### **INSTRUCTIONAL BULLETIN NO. 17-14**

### **Regarding Revised, New, and Voided Standard Drawings**

Effective March 23, 2018 letting (January 10, 2018 Turn-in), the following Standard Drawings have been revised or created. Also, Chapter 5 of the Roadway Design Guidelines has been revised to incorporate these changes.

S-GRA-3

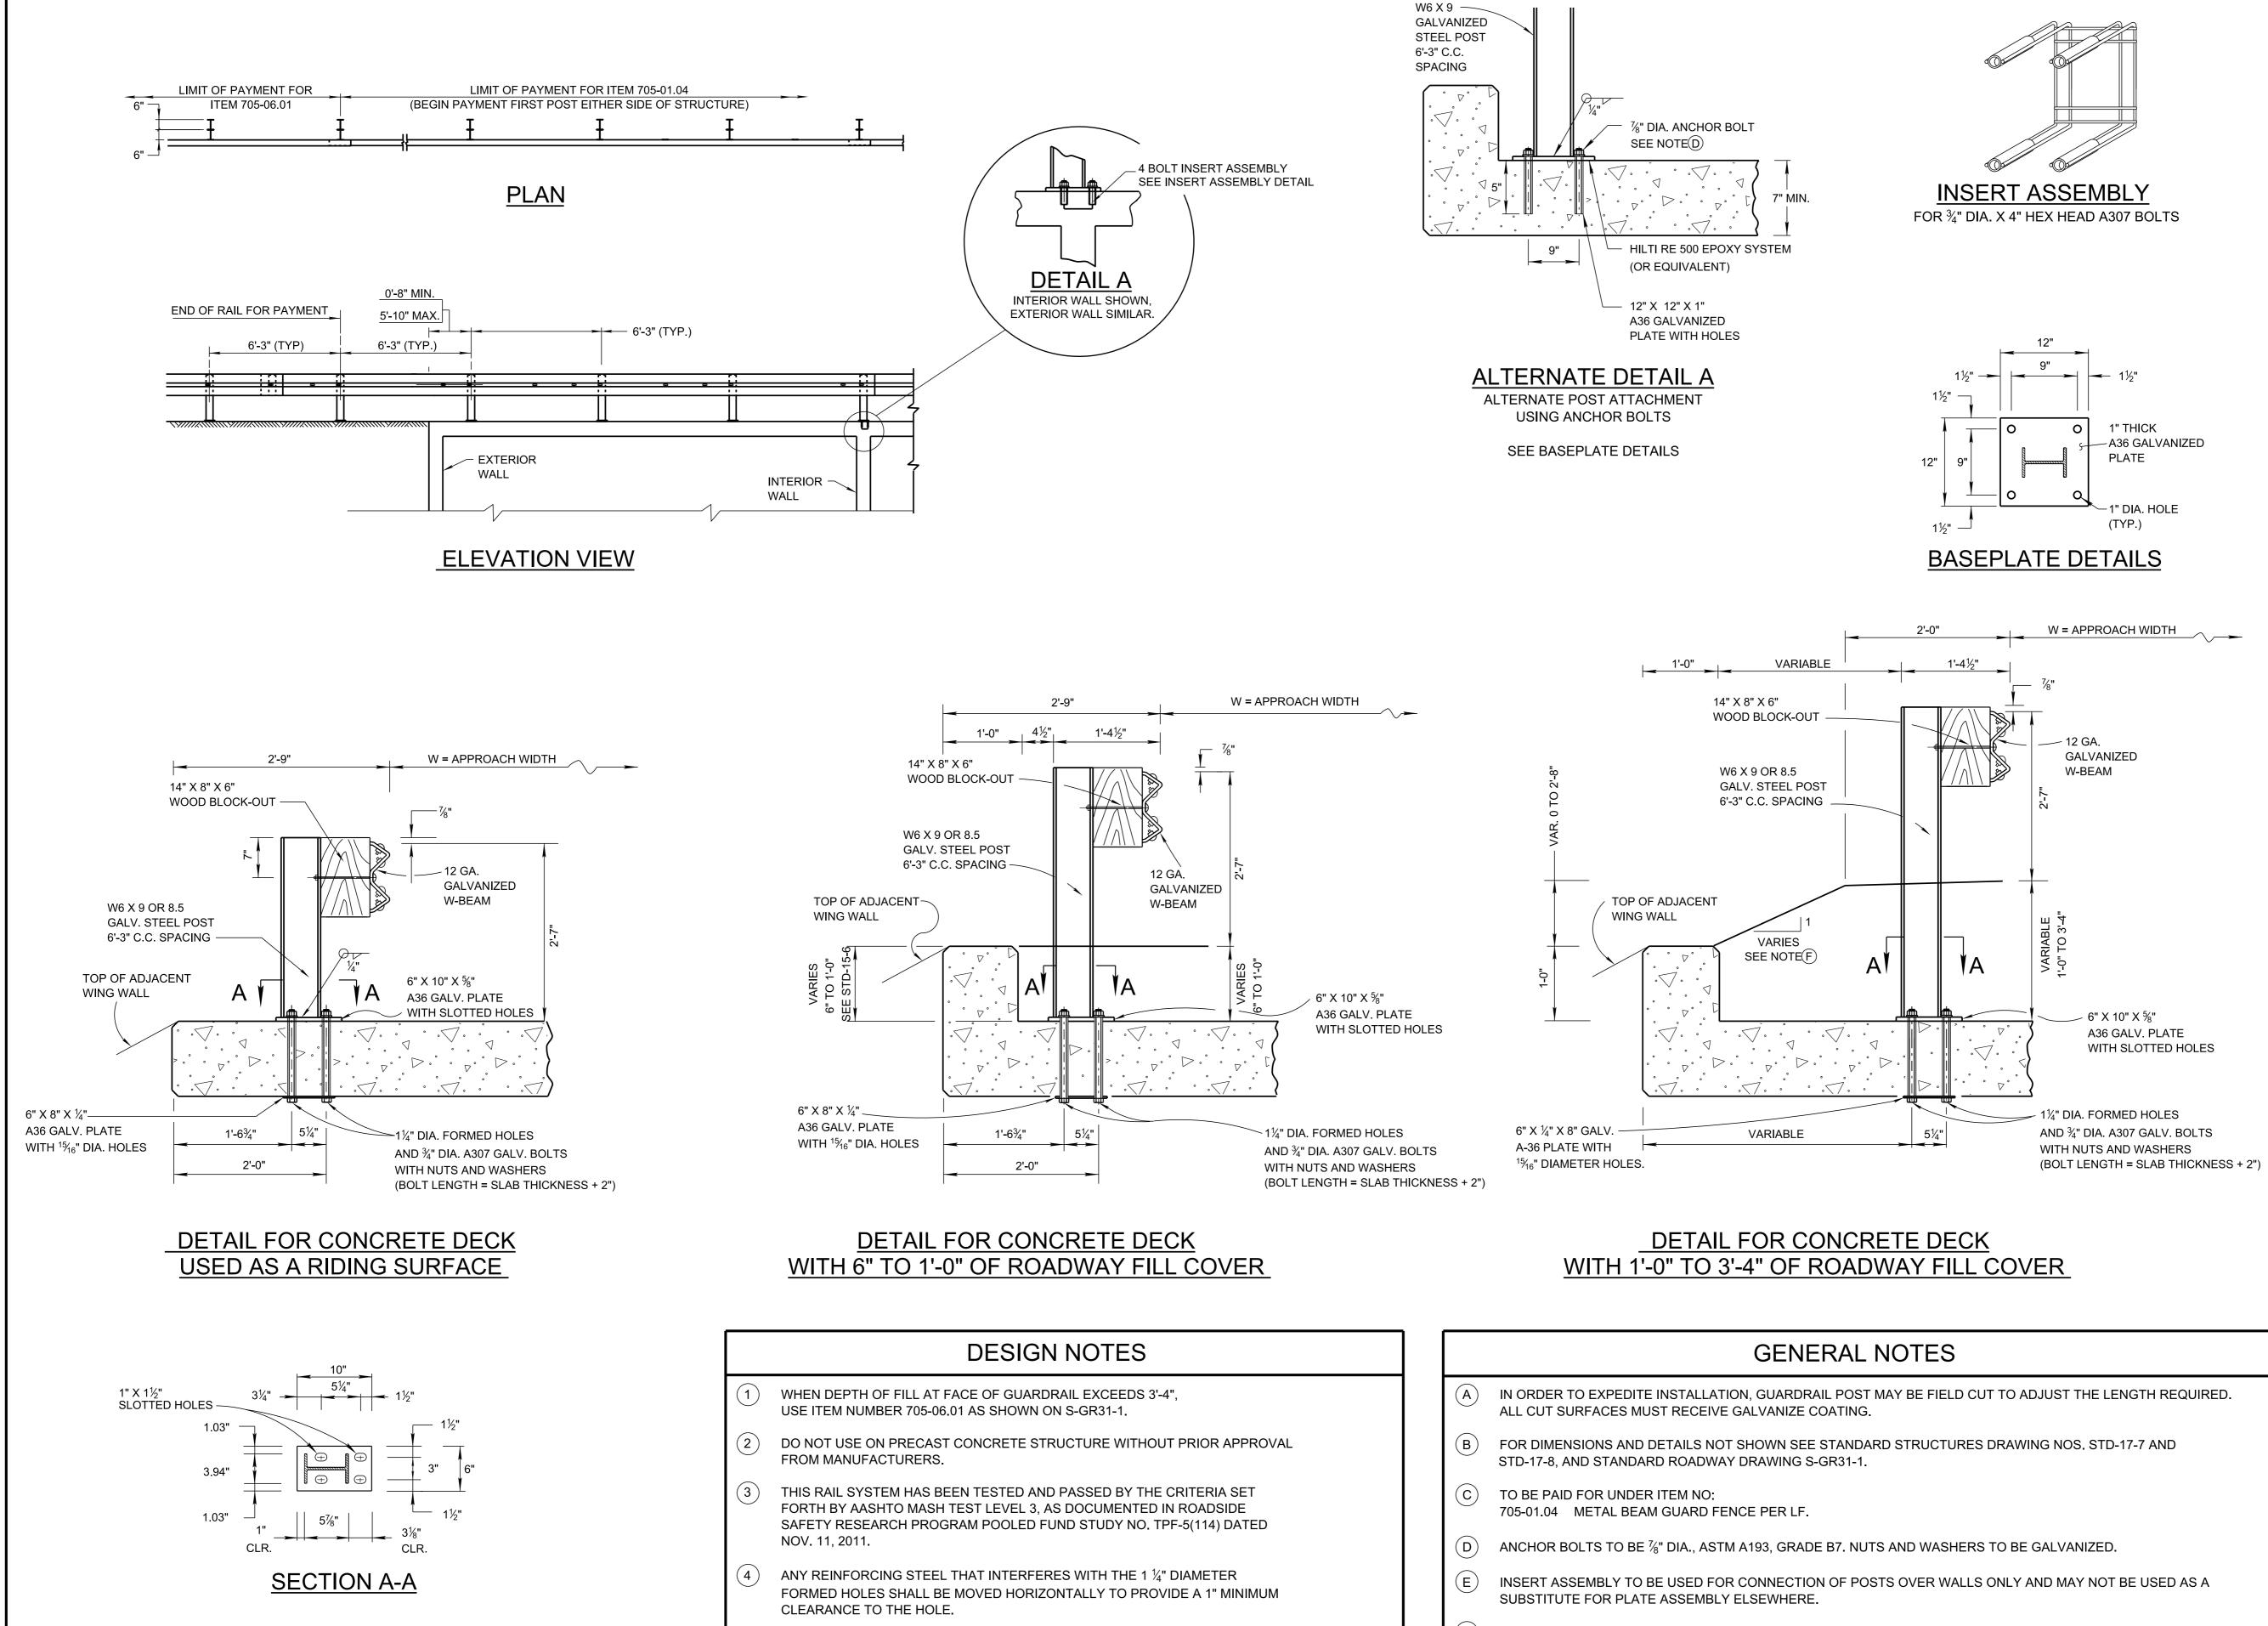
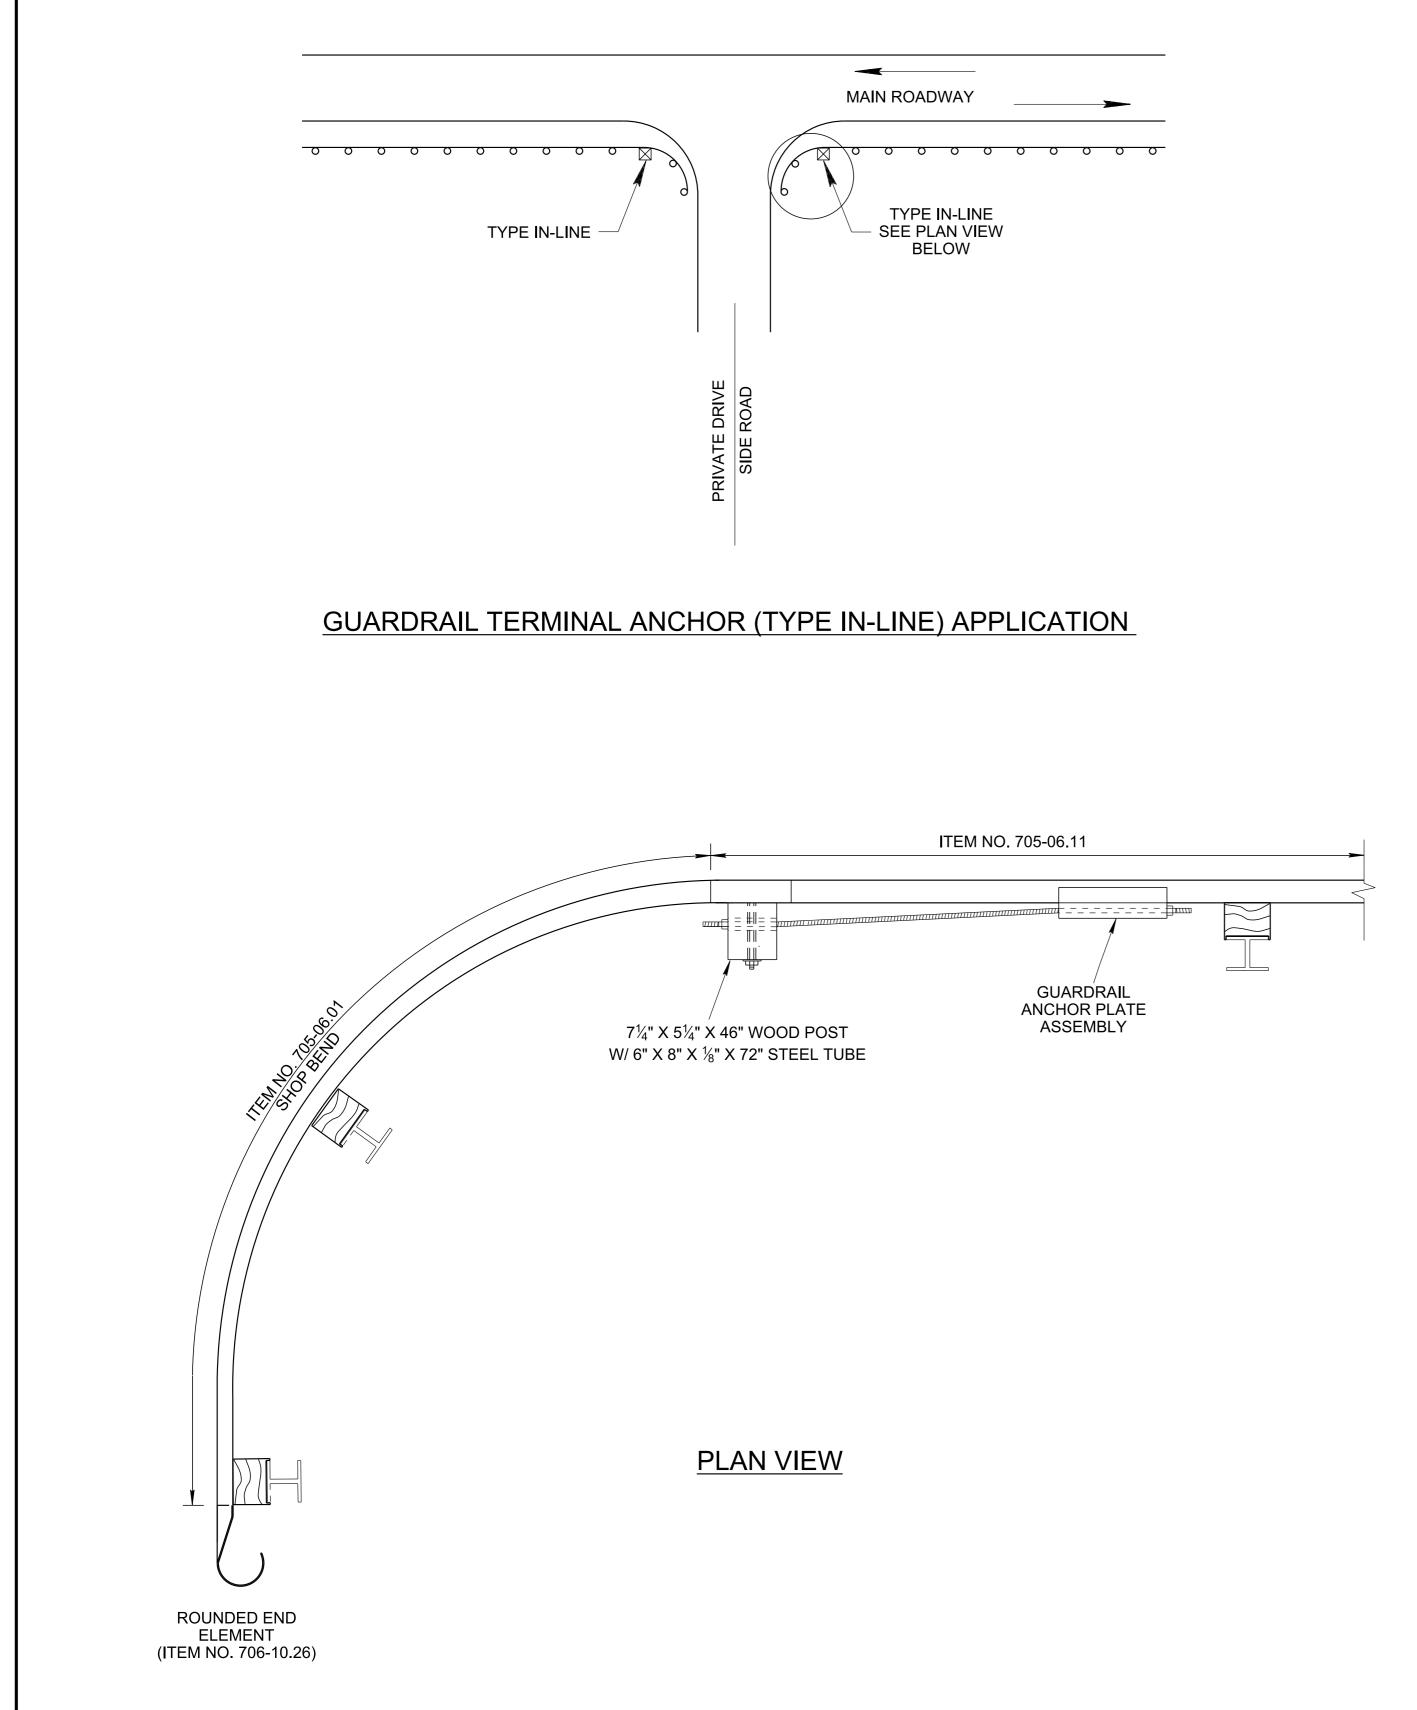
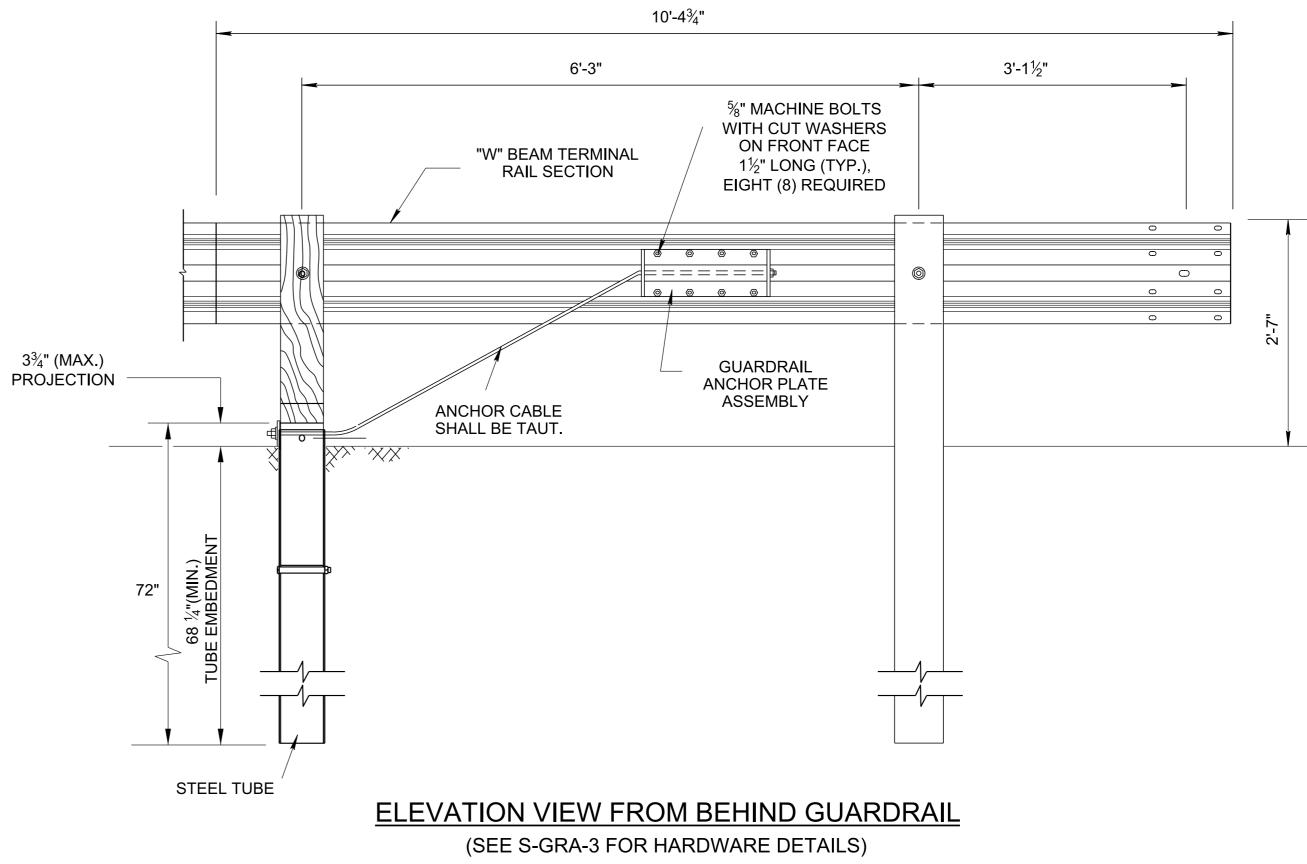
- REV. 5-27-16: REVISED POST SIZE IN PLAN VIEW. ADDED DIMENSIONS, REVISED DETAIL, REVISED NOTES.
- REV. 3-28-17: CHANGED PAY ITEM NUMBER.
- REV. 7-5-17: COMBINED THE TWO PLAN VIEWS. ADDED A DIMENSION TO THE ELEVATION VIEW.

|   | EVISION FHWA<br>L NOT REQUIRED. |  |
|---|---------------------------------|--|
| 7-11-13   | S-GRT-2P                        |  |

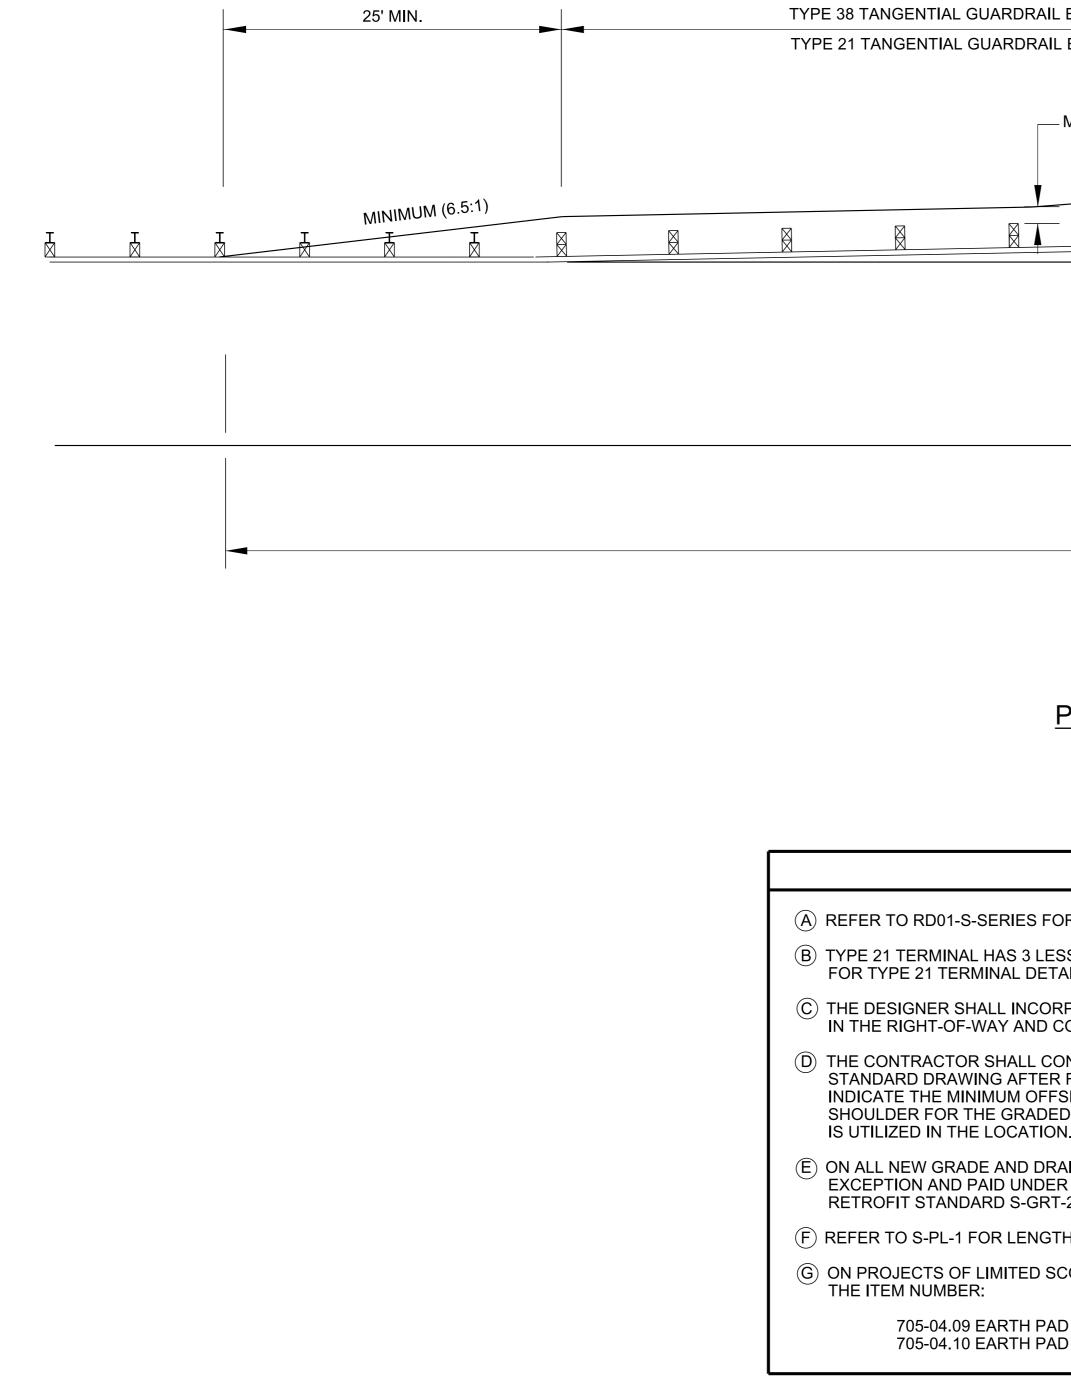
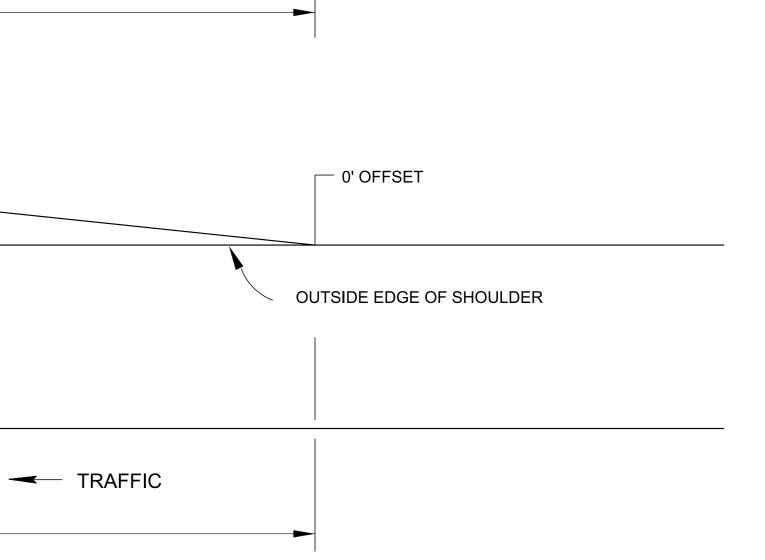
- REV. 5-26-16: CORRECTED PREFERRED TAPER RATE.
- REV. 7-5-16: UPDATED TITLE AND GENERAL NOTES TO INCLUDE TYPE 21 TERMINAL.
- REV. 7-5-17: ADDED ITEM NUMBERS TO THE PLAN VIEW.
